EARLY GRADING AND EROSION CONTROL PLANS SPRINGS AT WATERVIEW

EL PASO COUNTY, STATE OF COLORADO

PROJECT SPRINGS AT WATERVIEW
SHEET TITLE TITLE SHEET
FROM TO
JOB NO. 0102.1 SHEET 1 OF 6

PROJECT SPRINGS AT WATERVIEW
 SHEET TITLE GRADING & EROSION CONTROL PLAN
 FROM _____ TO _____
 JOB NO. 0102.1 SHEET 4 OF 6

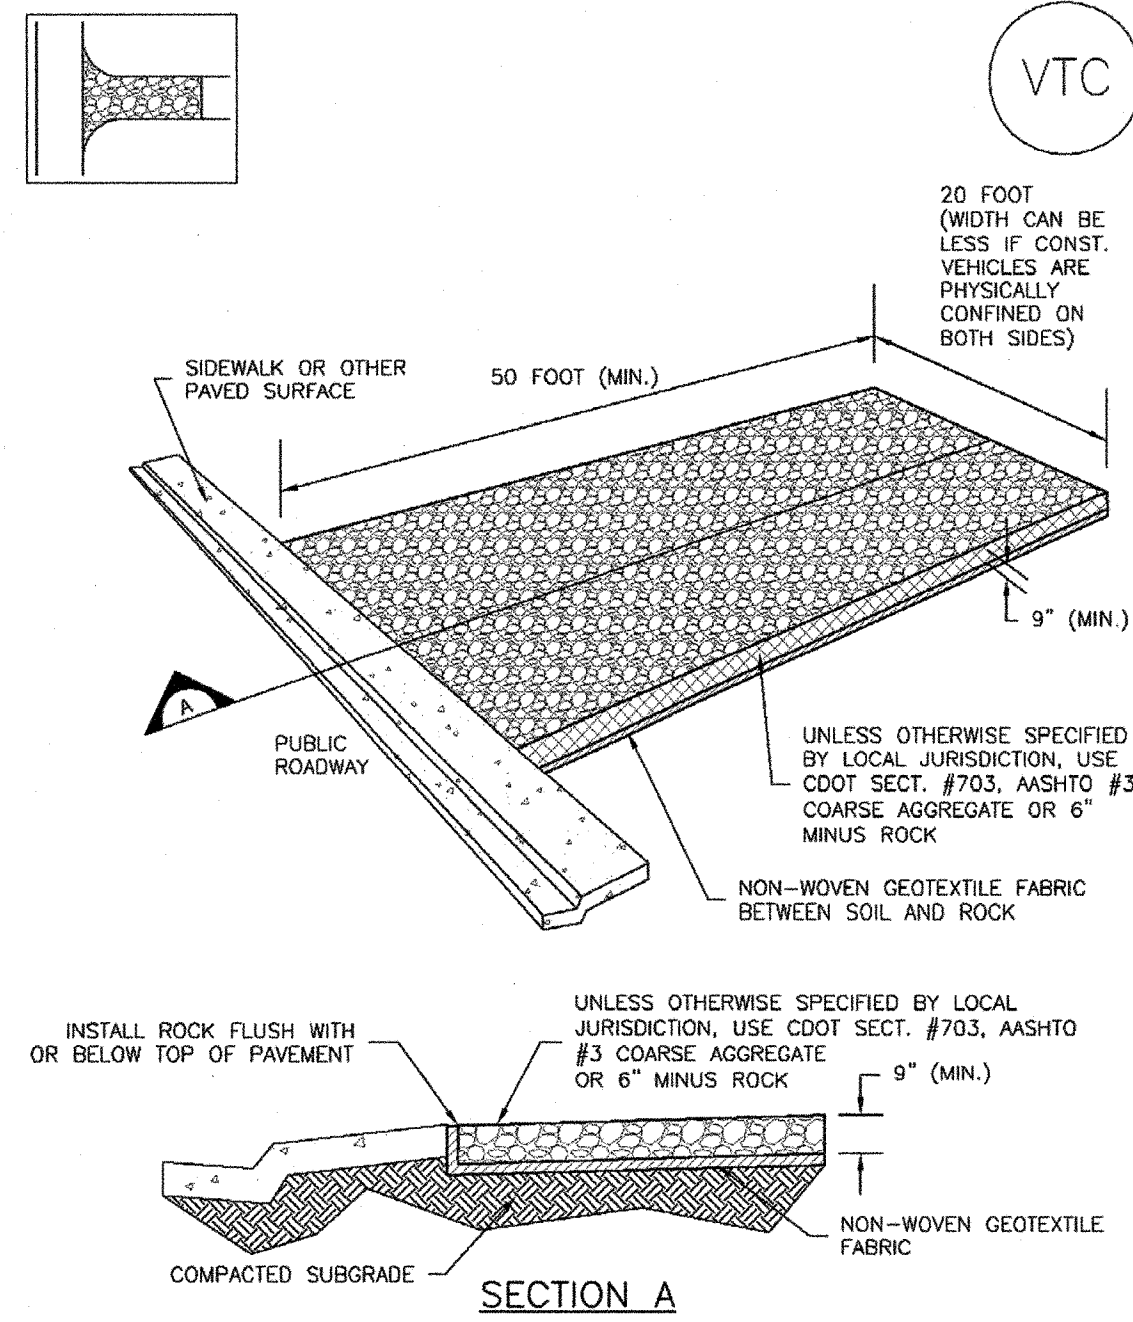
Contours shown and labeled to include bottom length/width as well as expected and designed volumes.

1. Show the actual design contours. Identify the minimum required volume

Identify RCS along these road segments

Add Inlet Protection

Add Inlet Protection

Roadway is less than 2%. RCS not required per UDFCD Standards. Confirmed by Charles

Added Type 1 Inlet Protection per UDFCD Standards

Added Type 1 Inlet Protection per UDFCD Standards

TABLE SB-1. SIZING INFORMATION FOR STANDARD SEDIMENT BASIN

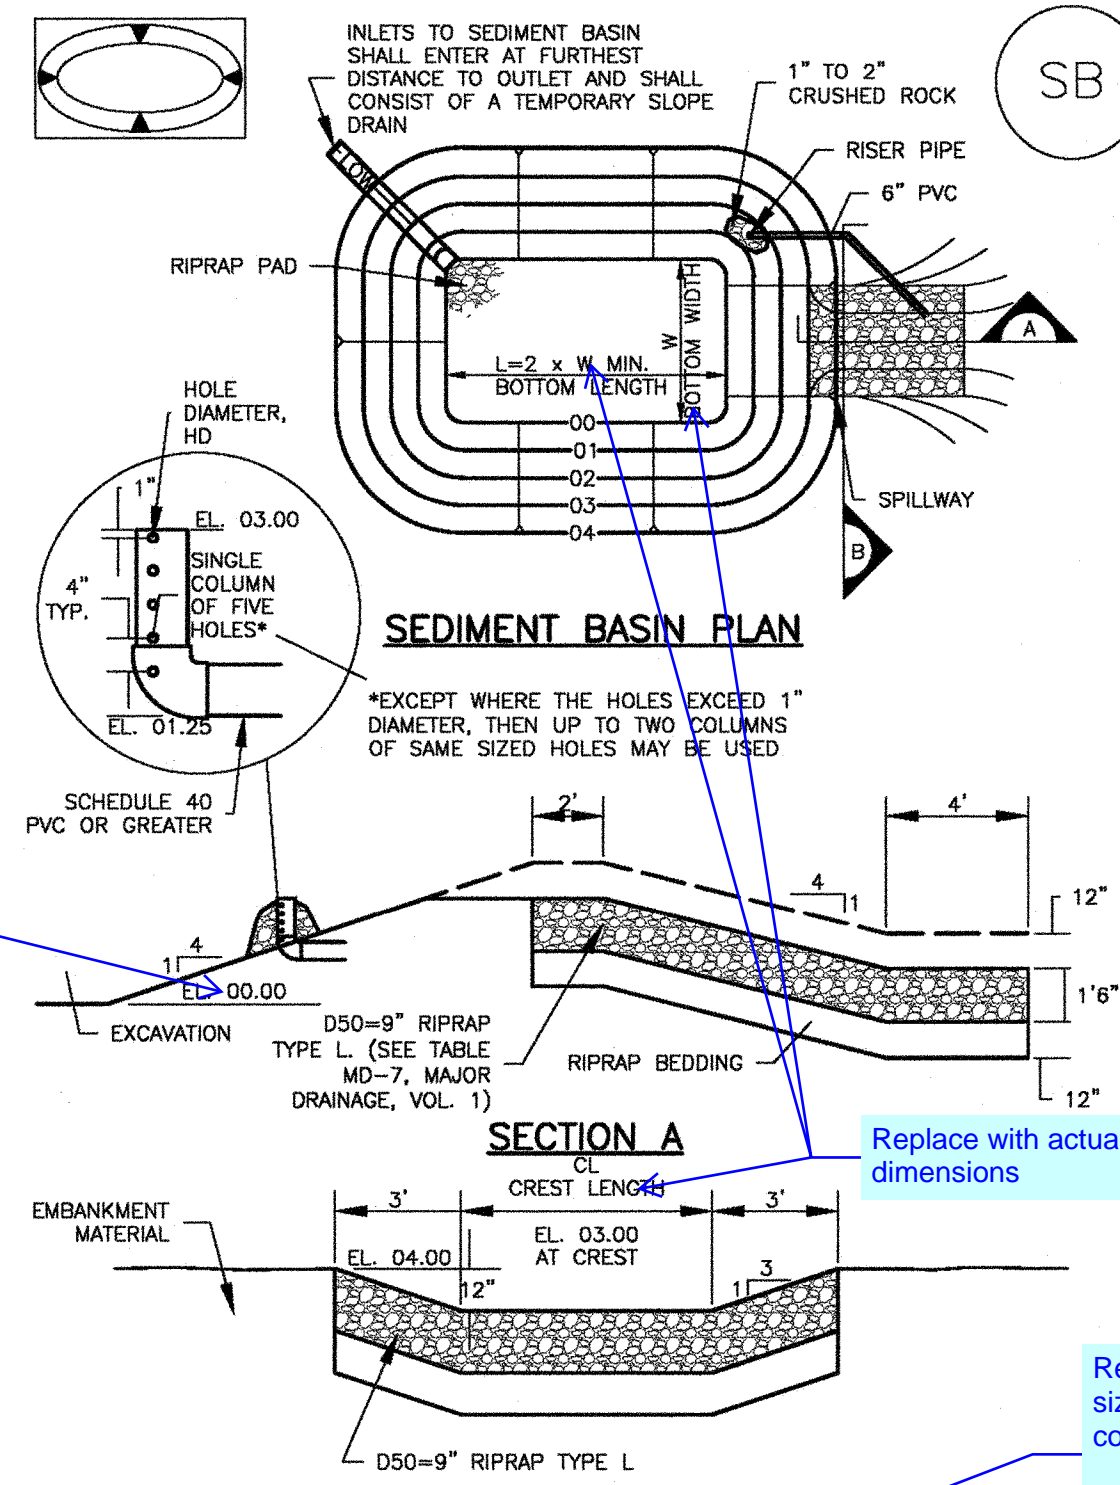
Identify the proposed elevation

Replace with actual dimensions

Remove the table and identify the actual required sizing for this temporary sediment basin to be constructed.

Reference elevations have been replaced with designed elevations

Dimensions referencing Table SB-1 have been replaced by designed dimensions

Table has been removed
